Conceptual Design of MICE RF Module (RFM) Vacuum System

January 27th, 2015

Andrew Lambert

Original RFM Vacuum Design

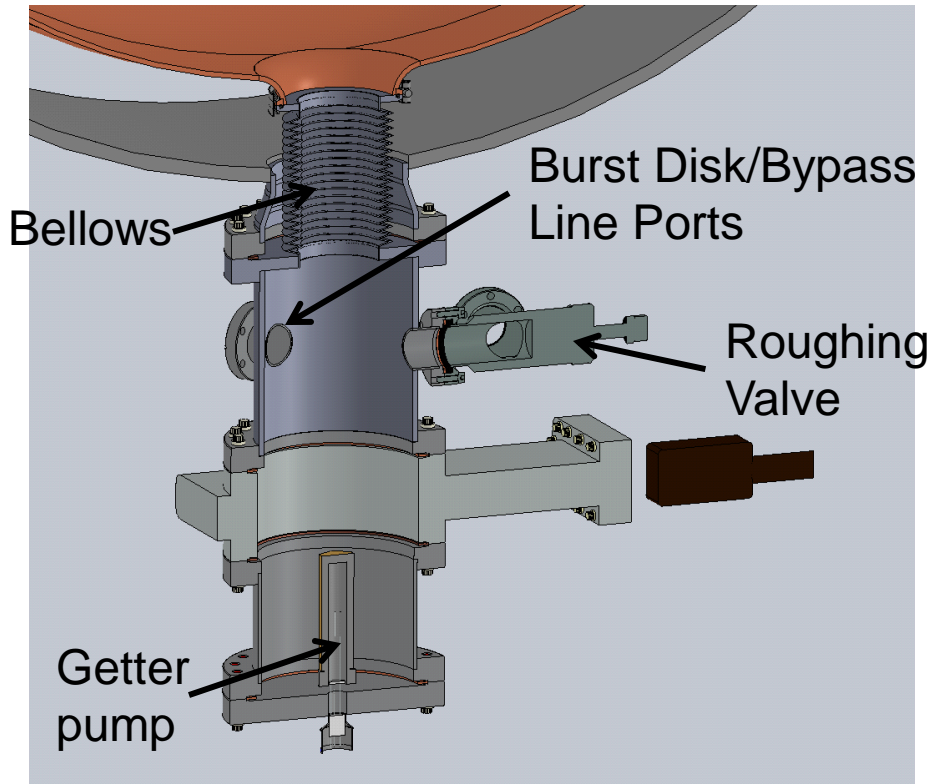
- Conductance between the two vacuum volumes
 - Exterior vacuum spoils the interior vacuum
 - Annular clearance has very large conductance
 - Instead pump on only the cavity with getter pump, use roughing system for exterior vacuum

New RFM Vacuum Design

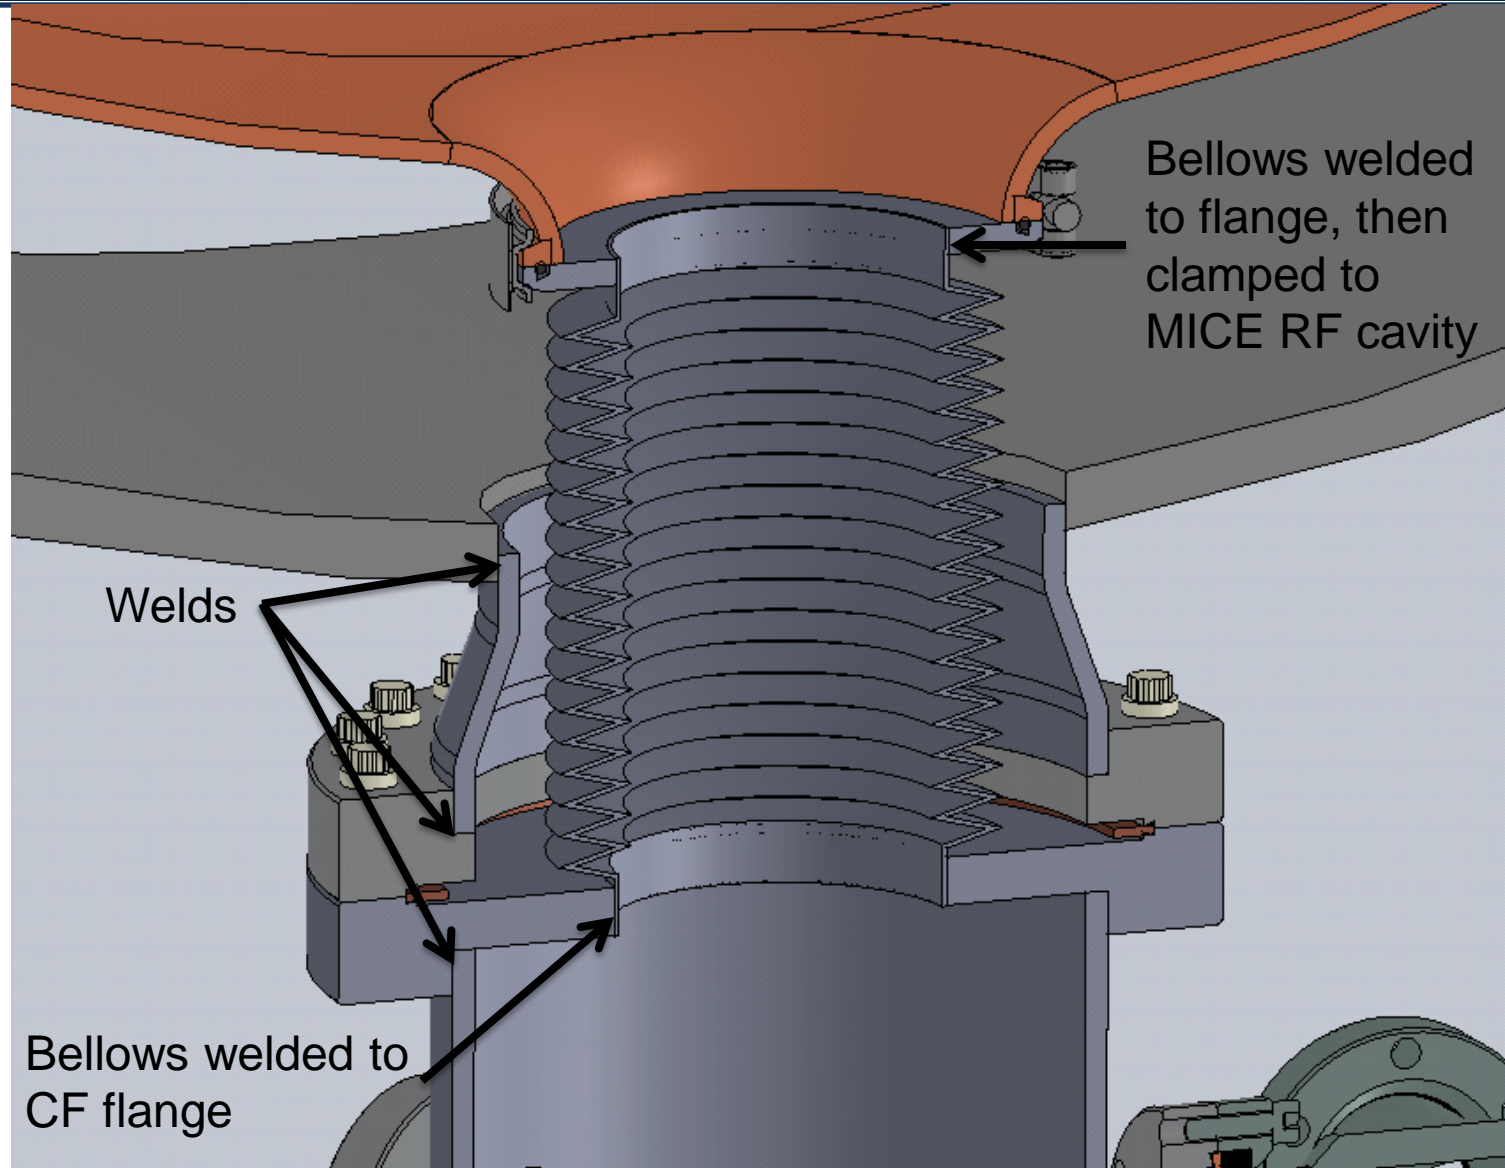
- Bellows connects the getter pump directly to the cavity
 - Getter only pumps on the cavity
 - Improve vacuum in the cavity
- Burst disk line will connect the two vacuum volumes
 - Protection in case of fault scenario
 - Burst disk should be sized to rupture at 0.5 psi
- Bypass line
 - Coat bypass line with getter material
 - Throttle valve allows for manipulation of the conductance from exterior vacuum to interior vacuum
